ROADWAY PLANS

JUDGE ORR ROAD RV PARK AND STORAGE

EL PASO COUNTY, COLORADO

JUDGE ORR ROAD RV PARK & STORAGE
COLORADO SPRINGS, COLORADO
ROADWAY OVERALL PLAN

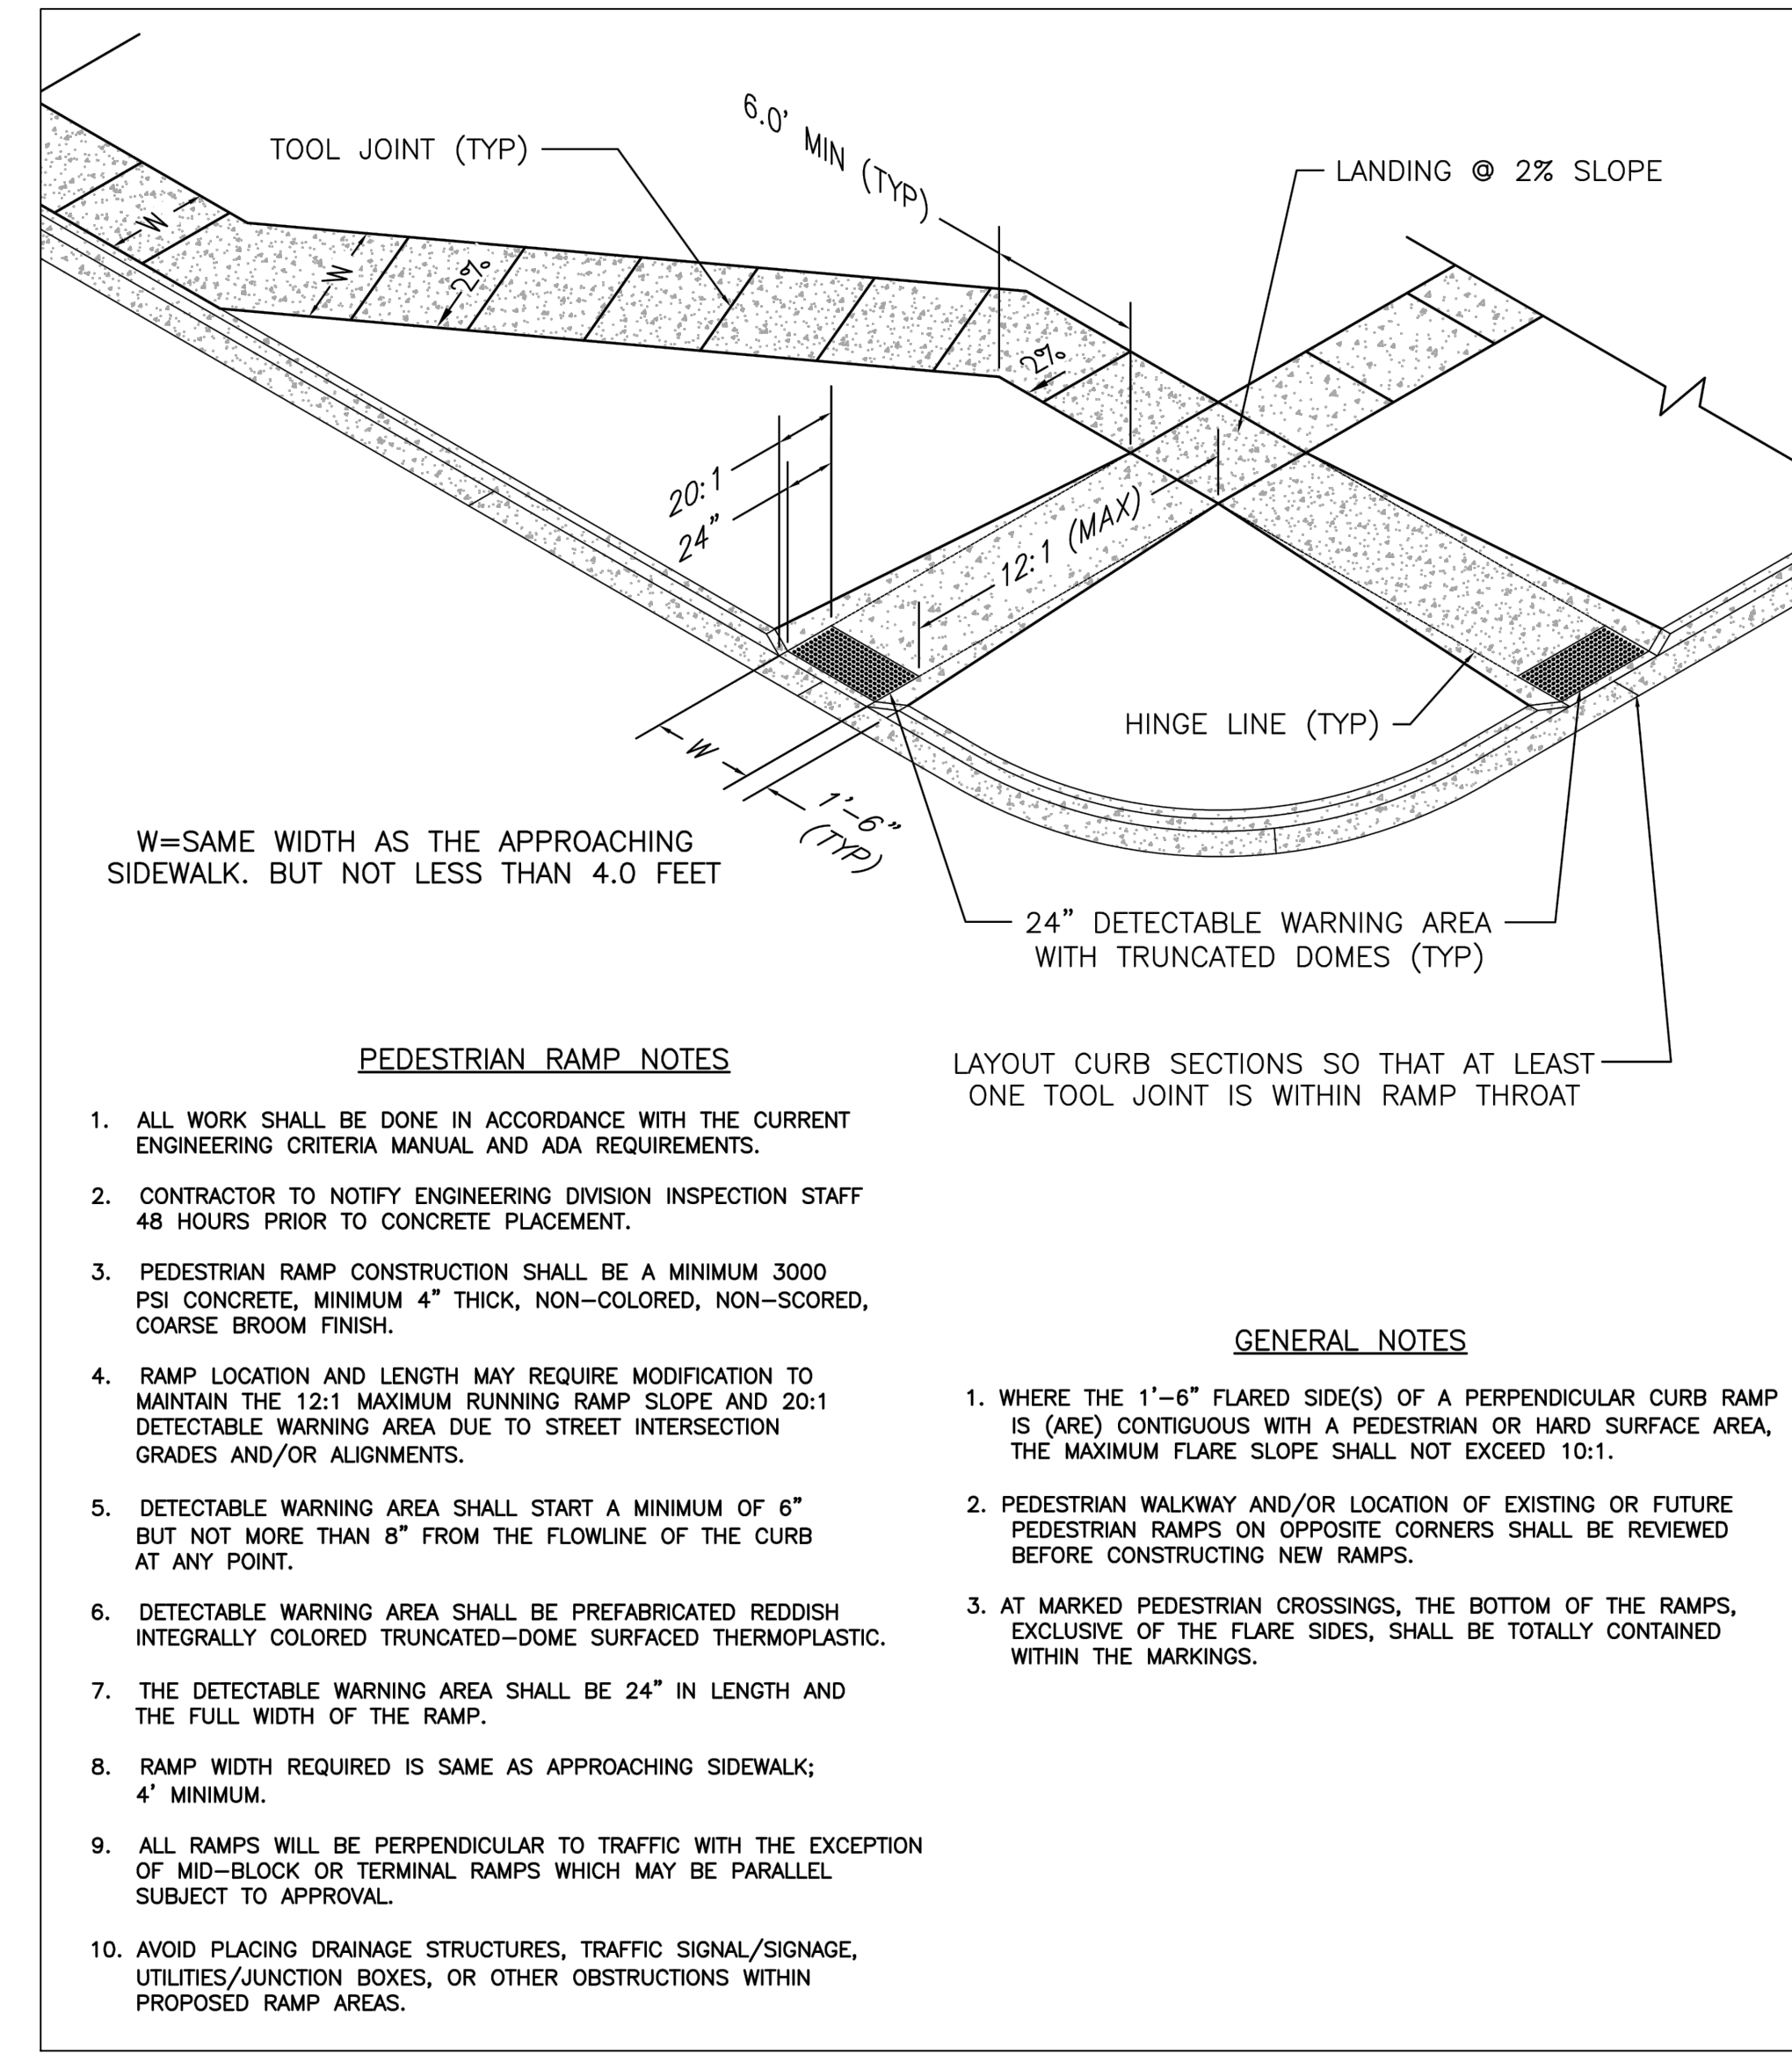
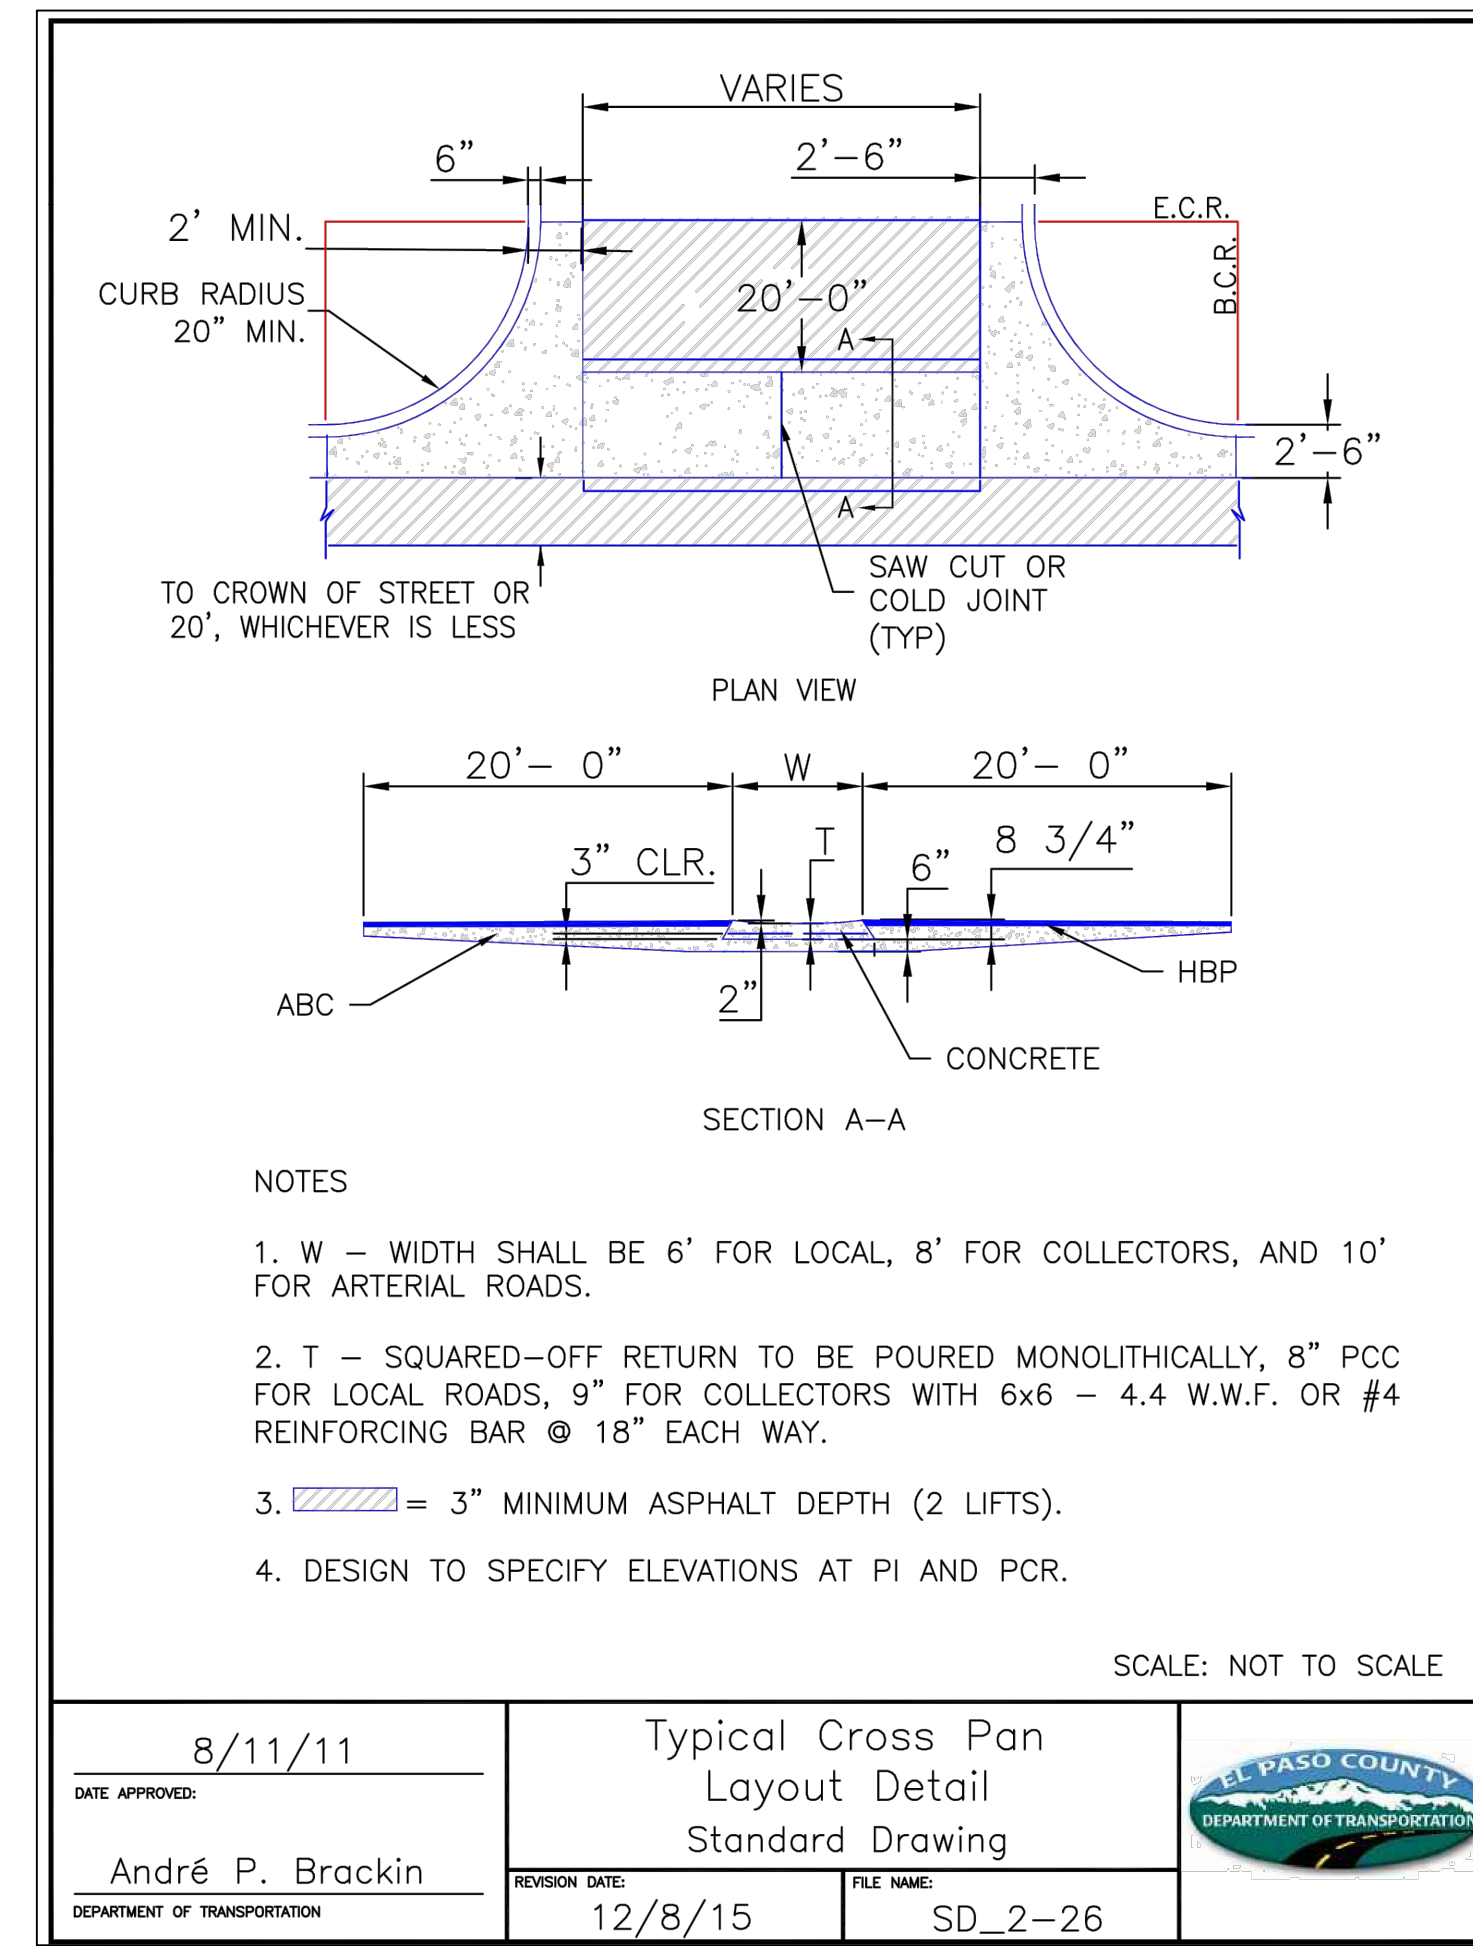
1. This does not match the width shown on the previous page. Update one or the other to match.

Label sidewalk as future. This is not necessary at this time. Staff recommends construction with the PUD development.

Future dedication will need to be wider so sidewalk is 0.5' inside the ROW, not outside.

Future dedication will need to be wider so sidewalk is 0.5' inside the ROW, not outside.

Label sidewalk as future. This is not necessary at this time. Staff recommends construction with the PUD development.

1. This does not match the width shown on the previous page. Update one or the other to match.

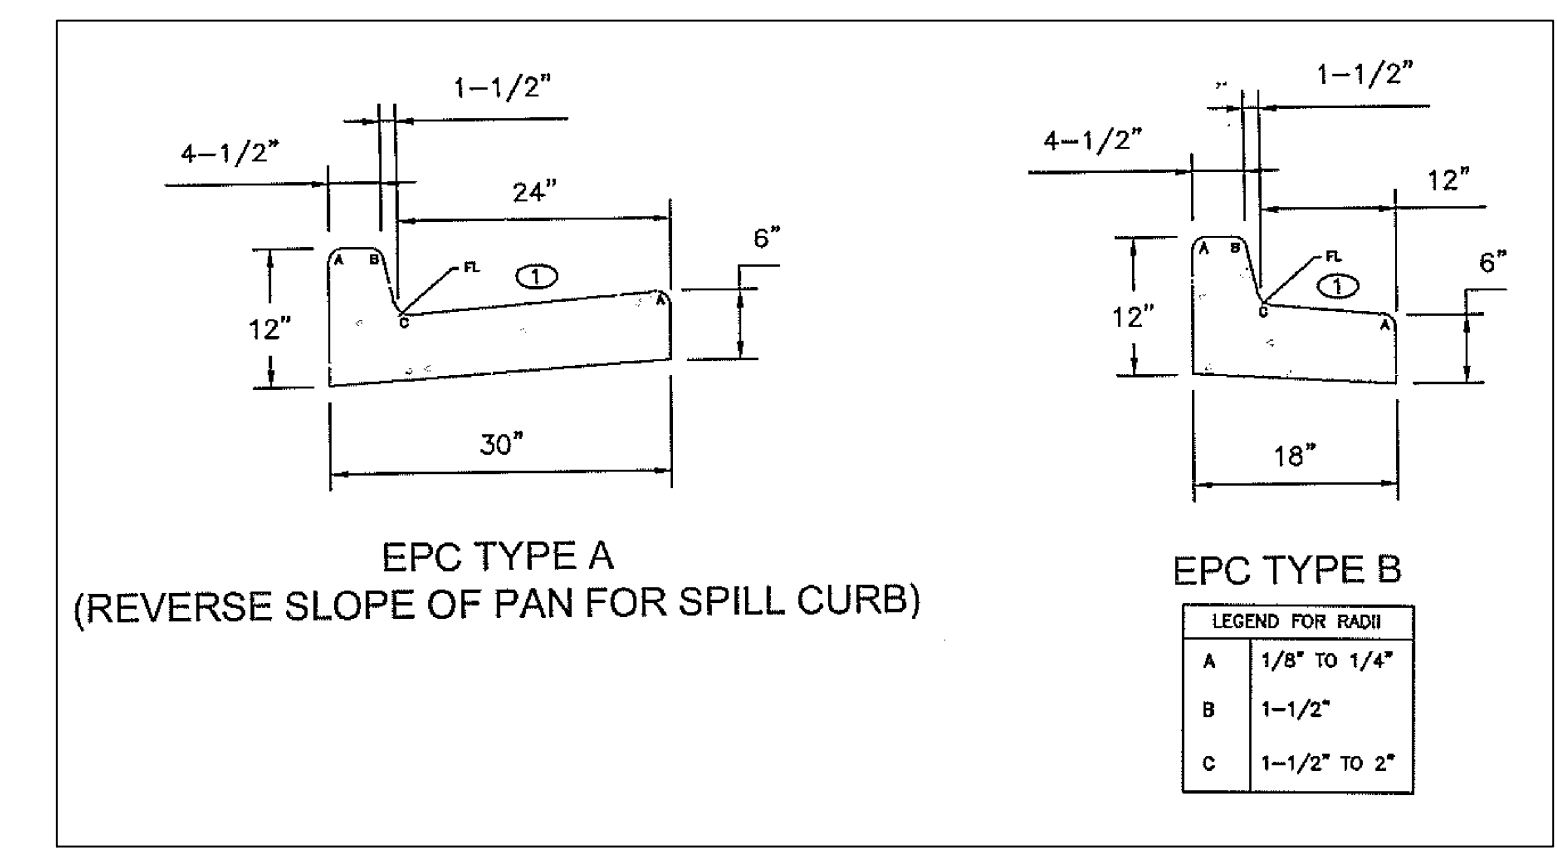
Revise to urban non-residential. Per ECM Section 2.2.4.B.5 Residential Collector is exclusively residential areas.

Unresolved. Per TIS Urban Non-Residential Collector

Revise to urban non-residential. Per ECM Section 2.2.4.B.5 Residential Collector is exclusively residential areas.

Unresolved. Per TIS Urban Non-Residential Collector
